SUBJECT: PDC06-062. PLANNED DEVELOPMENT REZONING FROM R-1-5 RESIDENCE ZONING DISTRICT TO THE A(PD) PLANNED DEVELOPMENT ZONING DISTRICT TO ALLOW UP TO 19 NEW SINGLE-FAMILY DETACHED ATTACHED RESIDENTIAL UNITS AND ONE EXISTING SINGLE-FAMILY RESIDENCE ON A 1.83 GROSS ACRE SITE, LOCATED ON THE TERMINUS OF DUCKETT WAY, APPROXIMATELY 420 FEET EAST OF SOUTH DE ANZA BOULEVARD (1566 DUCKETT WAY).

File Number
PDC06-062

STAFF REPORT

Subject: City File No. PDC06-062, Planned Development Rezoning

ALTERNATIVE SITE PLAN THAT MEETS 8.0 DU/AC

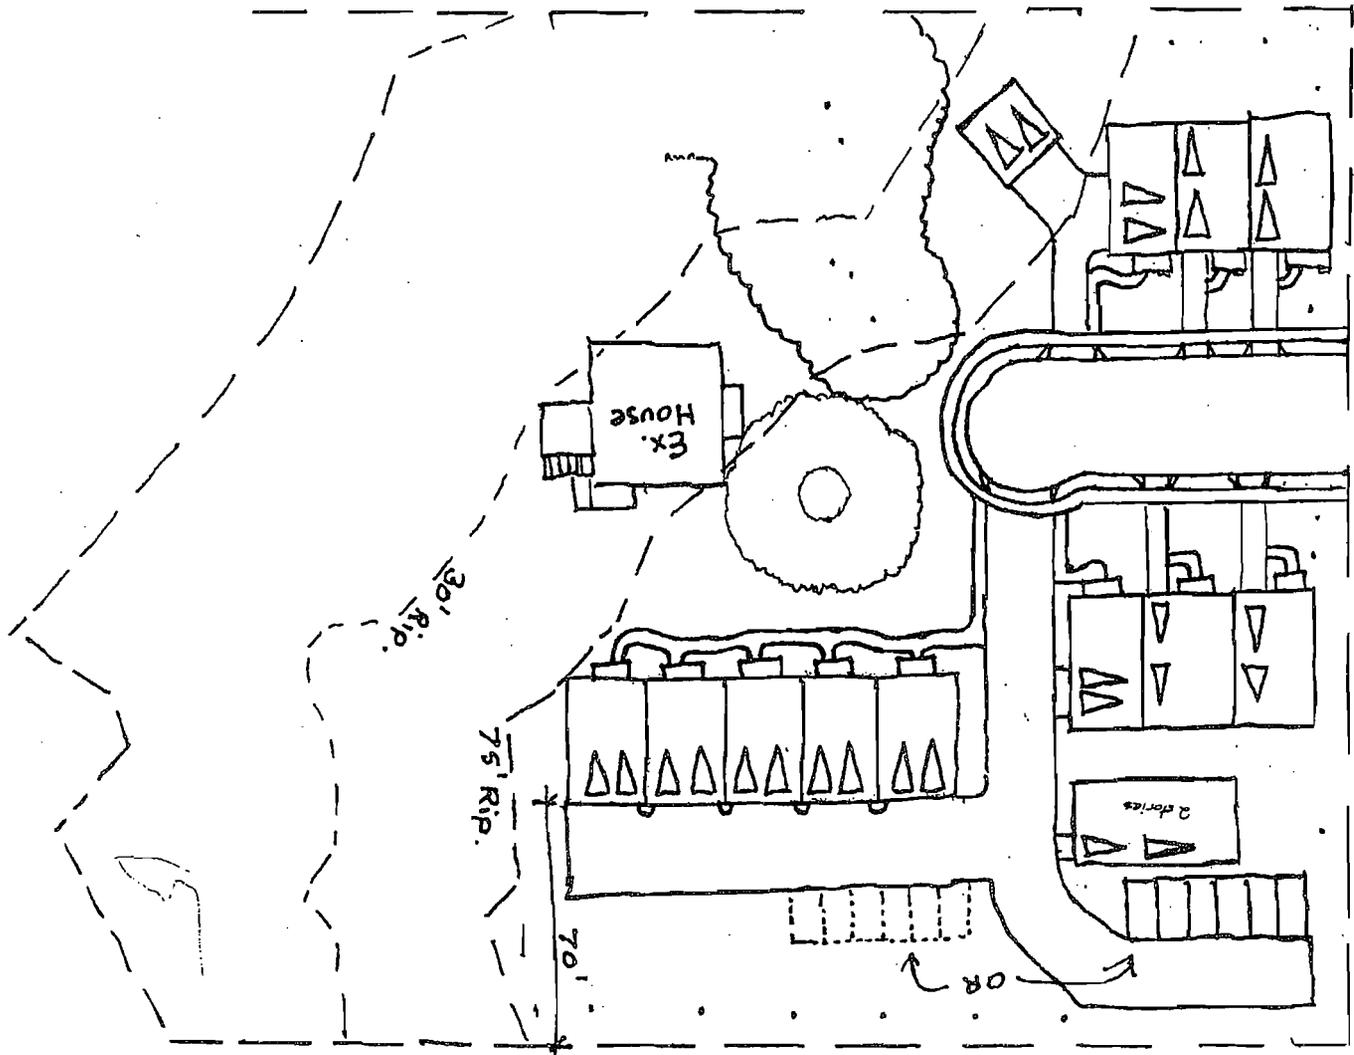
Staff then presented a site plan which included 12 attached single-family homes and retained the existing California Register eligible historic home. The site plan was presented for visualization purposes so that the audience and Commission could have an example of how the recommendations of the Riparian Corridor Policy and Residential Guidelines could be easily met on the site. The site plan, with 13 total units, also demonstrated that the current General Plan designation promotes development with a density that would meet all the City goals and policies. The site plan was designed to illustrate the design comments that were articulated in staff's initial comment letter to the applicant.

Staff acknowledged that they did not provide the alternate site plan to the applicant prior to the night's hearing. The alternate site plan was for illustrative purposes only. Again, Staff was not recommending approval of this alternative but rather using this as an exhibit for the Planning Commission to illustrate the specific written comments given to and/or discussed with the applicant early in the review process. Staff does not usually redesign projects for applicants, but rather provides feedback to design professionals regarding an application's conformance to ordinances and policies.
